No. 97-21

## Required ECM Replacement

### Models

- a - Check Sum Number on White Tag.  
b - J1 Harness Connector to ECM.  
c - J1-4 Pin Location-Incorrect.  
d - J1-6 Pin Location-Correct.

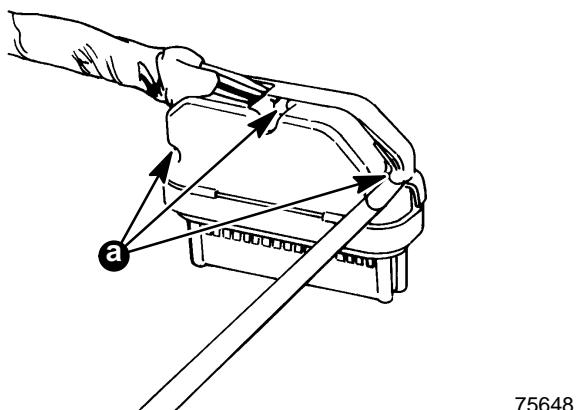
ECMs with check sum number '9371,' '9375' or '9361' for 350 MPI or 'A012' for 7.4L MPI are good. Inspect the electrical harness J1 connector to make sure that the BRN wire is in the J1-6 pin location instead of the J1-4 location. Refer to drawing on page 4 for J1-6 location. Follow instructions outlined under 'Changing Pin Location' to change wire/pin location if BRN wire/pin is in the J1-4 location.

Change any ECMS that have a check sum number listed in 'a' or 'b', preceding. Be sure the BRN wire/pin in the J1-6 location.

75648

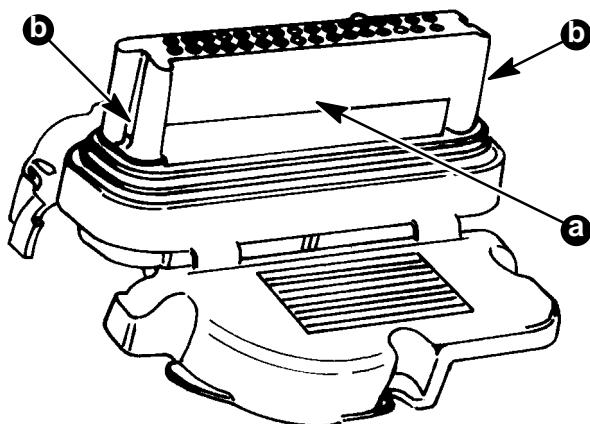
1. Remove the J1 connector from the ECM.
2. Open the connector housing by lifting the locking tabs.

75649

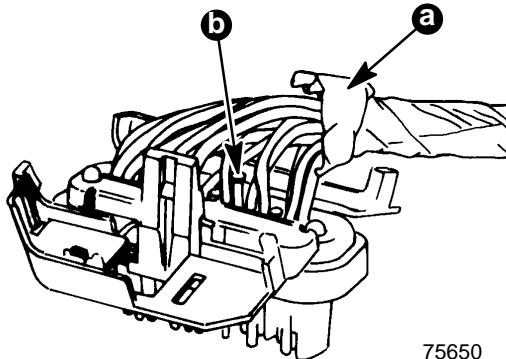
3. Remove the pin protector by pressing in on locking tabs on both ends of the protector.

75650

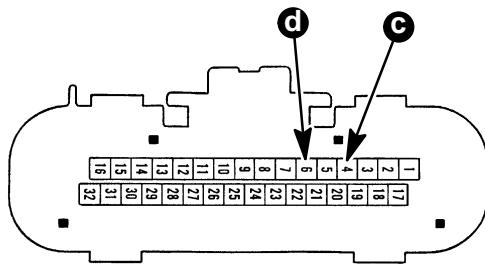
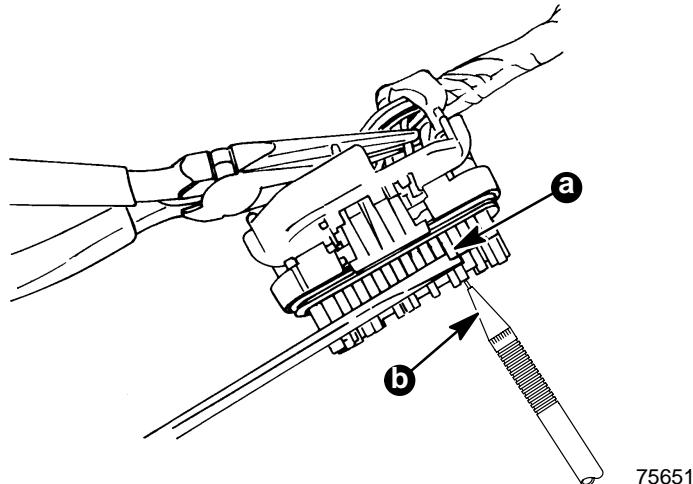
4. Roll the electrical tape back far enough so that you can work with the wires.
5. Remove the plastic plug from the J1-6 pin location.
6. Move the harness wires so they are aligned straight with the connector holes. This will make it easier to push the BRN wire/pin up and out of its hole.

75651

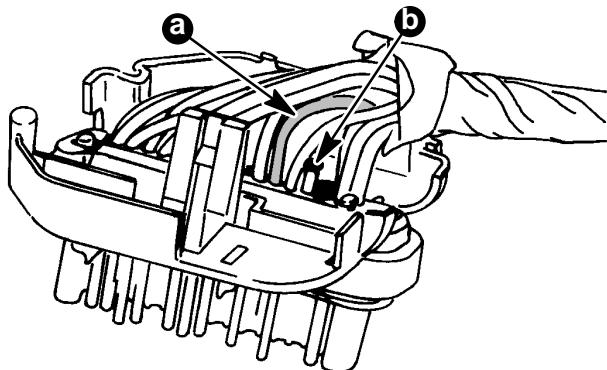
7. While lifting 'up' on the pin's locking tab, use the metal tip of a mechanical pencil to push the pin up and out of the J1-4 pin location. When first starting to push on the BRN wire/pin, lift the pin slightly toward you and push up.
